Hallam Office Building
Phase II Shell Space
1225 NE Douglas St.
Lee's Summit, Missouri 64082

Attic Access

ASi201-1

1 RCP Upper Level

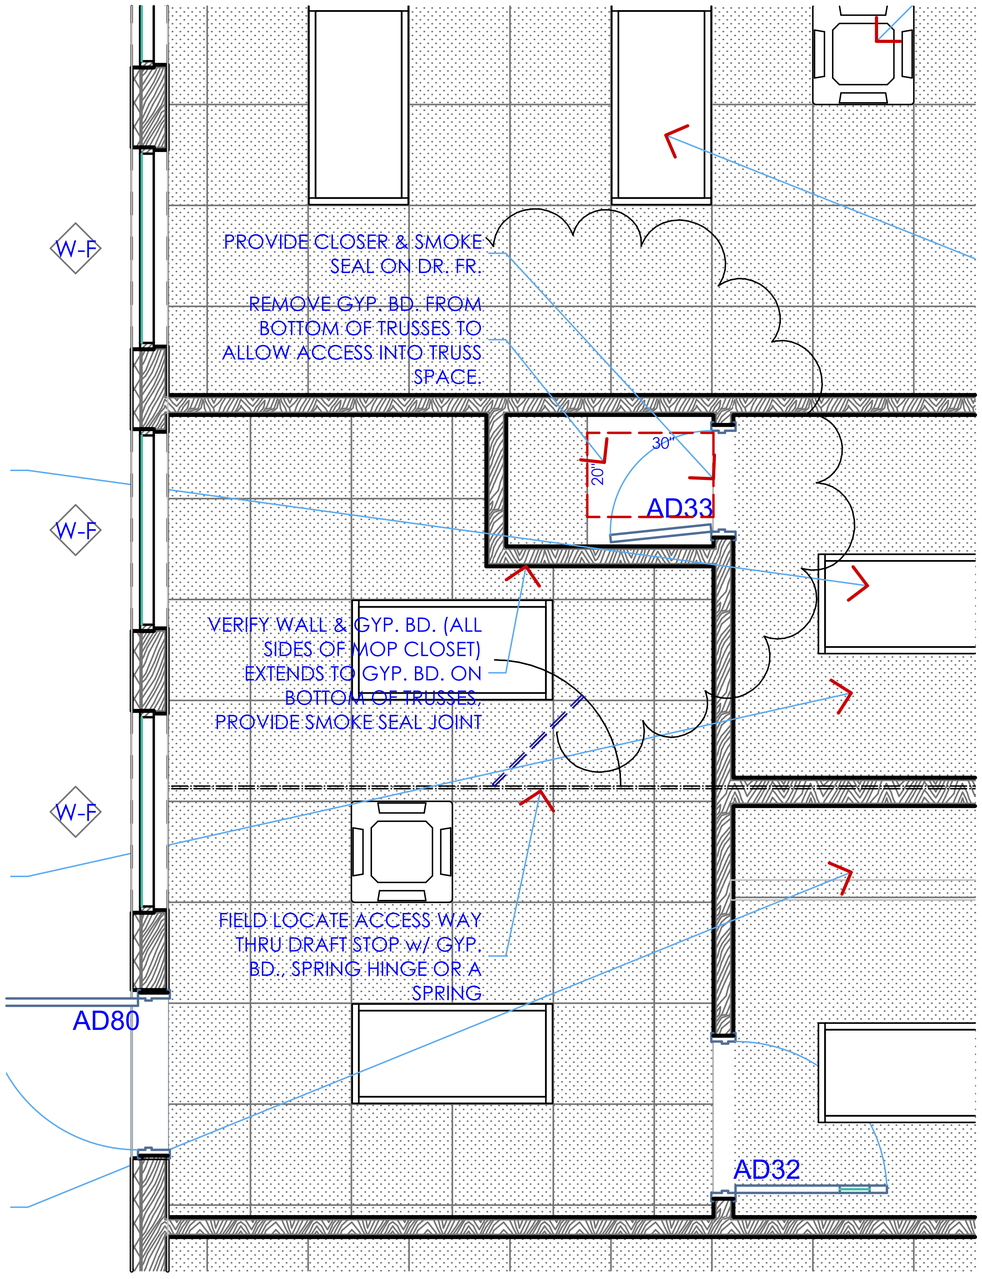
1. VERIFY THE WALLS (BOTH SIDES) IN THE NEW MOP CLOSET EXEND TO THE GYP. BD. ON BOTTOM OF STRUCTURE. TRUSSES ARE PLACED @ 16" O.C. AND TRUSSES ARE NOT CAPABLE OF MODIFICATION.
2. PROVIDE SPRING ON GYP. BD. DOOR ON DRAFT STOP.
3. PROVIDE CLOSER & SMOKE SEAL ON MOP CLOSE DOOR.
4. REMOVE GYP. BD. FROM BORROM OF STRUCTURE INSIDE MOP CLOSET AREA PROVIDING OPENING INTO ATTIC SPACE.
